Peaceful Ridge at Fountain Valley
Traffic Impact Analysis
(LSC #S214530)
December 10, 2021

LSC Responses to TIS Comments

Figure 1
Vicinity Map
Peaceful Ridge (LSC# S214350)

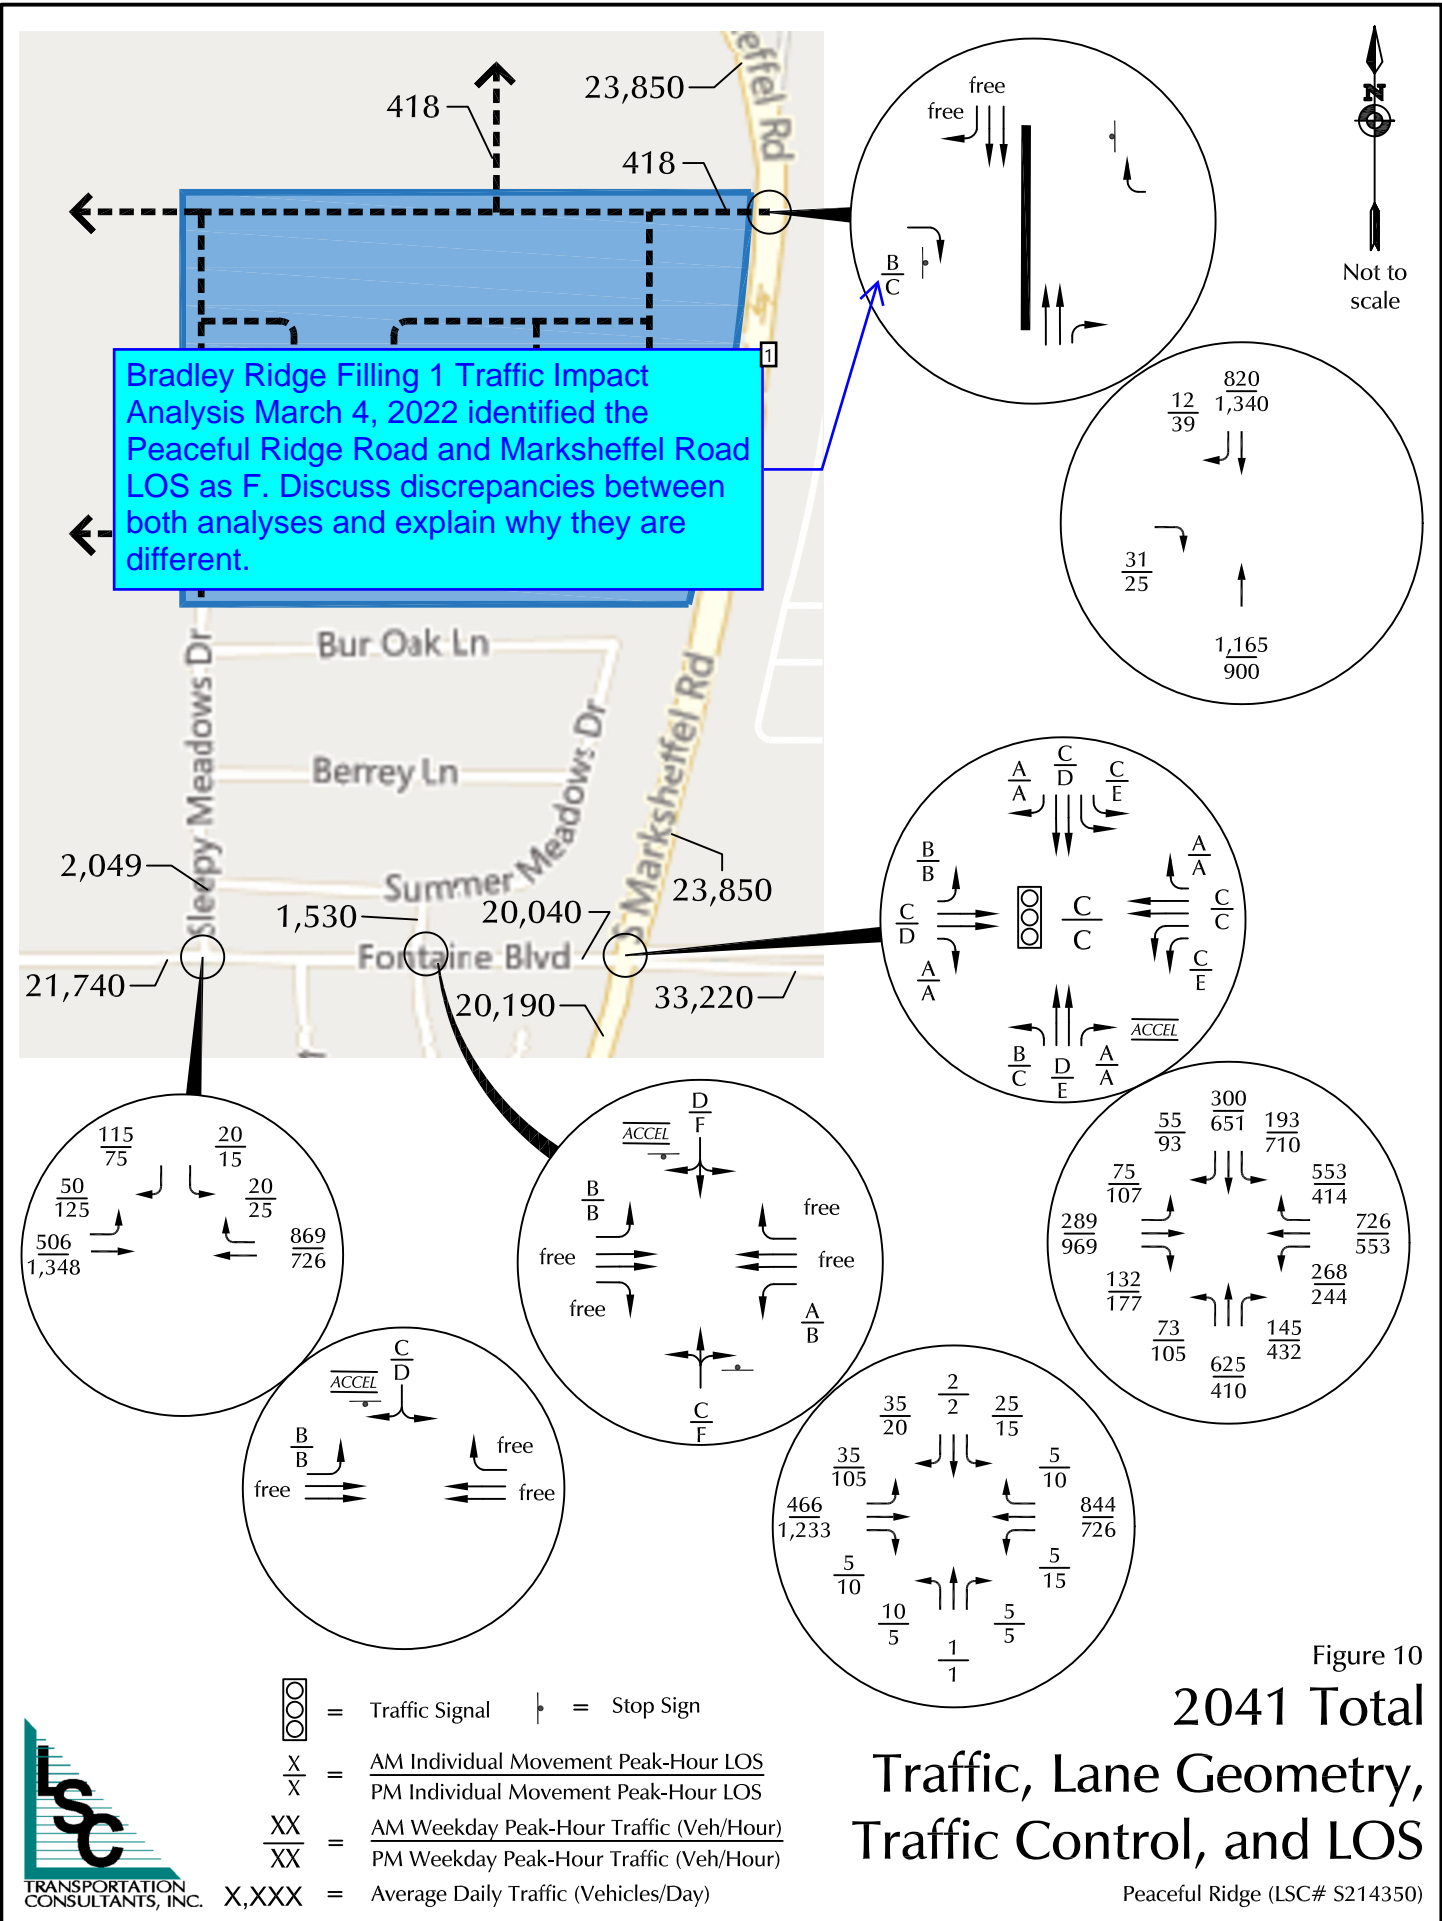
There are no connections shown to the west on the plat. Revise vicinity maps and subsequent maps.

There are no connections shown to the west on the plat. Revise vicinity maps and subsequent maps.

Author: jchodsdon Subject: Sticky Note Date: 5/5/2023 16:21:02
LSC Response: Revised as requested.

Figure 11

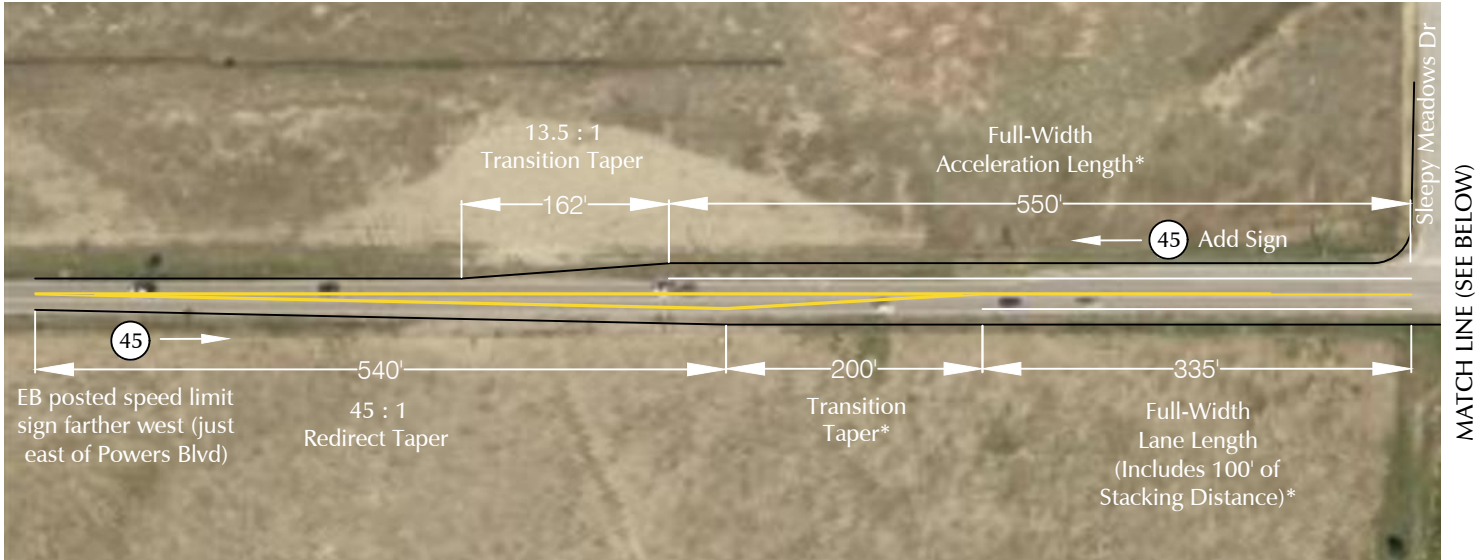
[Bradley Ridge Filling 1 Traffic Impact Analysis March 4, 2022 identified the Peaceful Ridge Road and Marksheffel Road LOS as F. Discuss discrepancies between both analyses and explain why they are different.](#)

Include propose improvements for Marksheffel Road and Peaceful Ridge Drive intersection and Marksheffel Road and Fontaine Boulevard.

[Include propose improvements for Marksheffel Road and Peaceful Ridge Drive intersection and Marksheffel Road and Fontaine Boulevard.](#)

LSC Response: Although Marksheffel is currently one through lane in each direction, our 2045 analysis assumes Marksheffel widened to a four-lane facility by 2045.

Author: jchodsdon Subject: Sticky Note Date: 5/10/2023 13:03:19

LSC Response: Marksheffel/Peaceful Ridge Drive improvements included on a separate, new figure.
